Access Review

St Anthony of Padua Catholic
School Austral, Masterplan

Report Issue 1

13/07/18

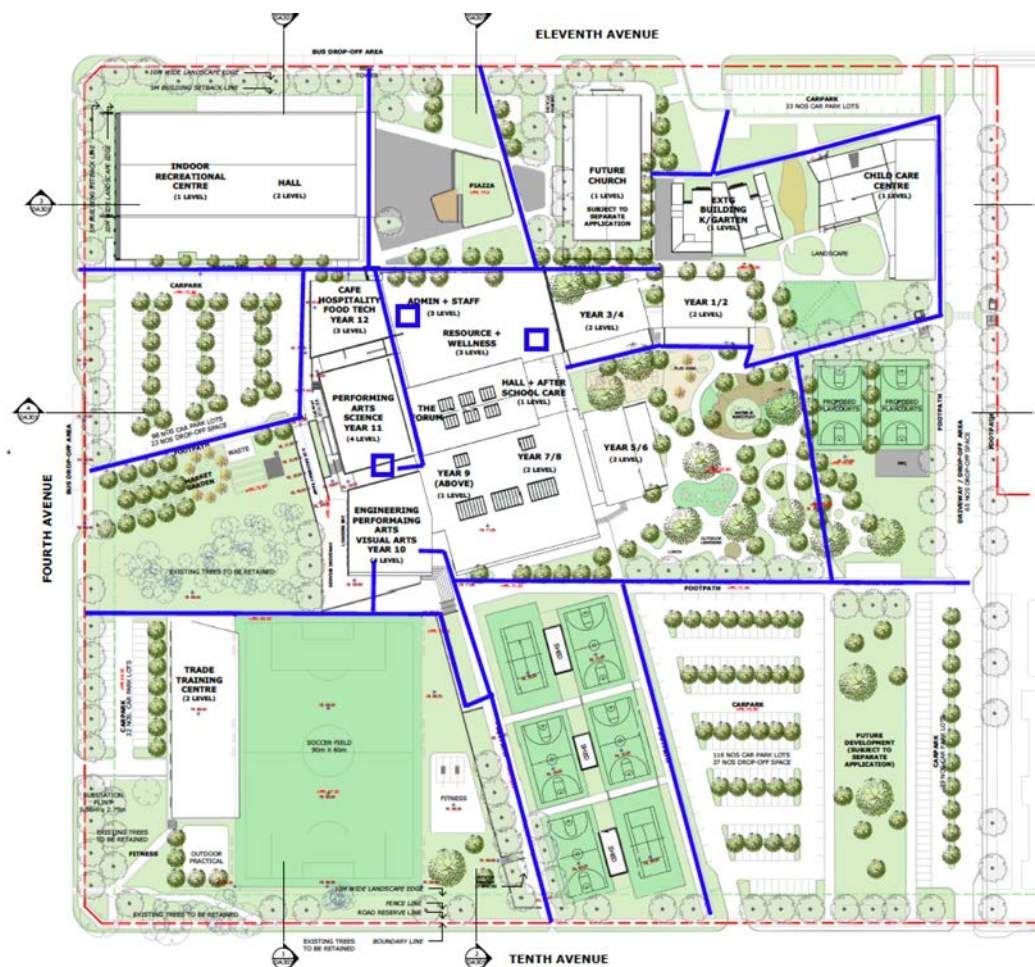
The following diagram shows the proposed provision of continuous accessible paths of travel through the school and lifts (blue boxes) linking all facilities and buildings. A lift is proposed to be added to the Trade Training Centre to link the two levels.

A continuous accessible path of travel is an uninterrupted route to and within premises providing access to all features, services and facilities. It is any step free and safe. A continuous accessible path of travel should extend to all amenities and areas to which the public (including employees) is entitled or allowed to enter or use.

A continuous accessible path of travel should be the most commonly used and direct path of travel. If for any reason this is not possible, clear signage of the alternative route should be provided.
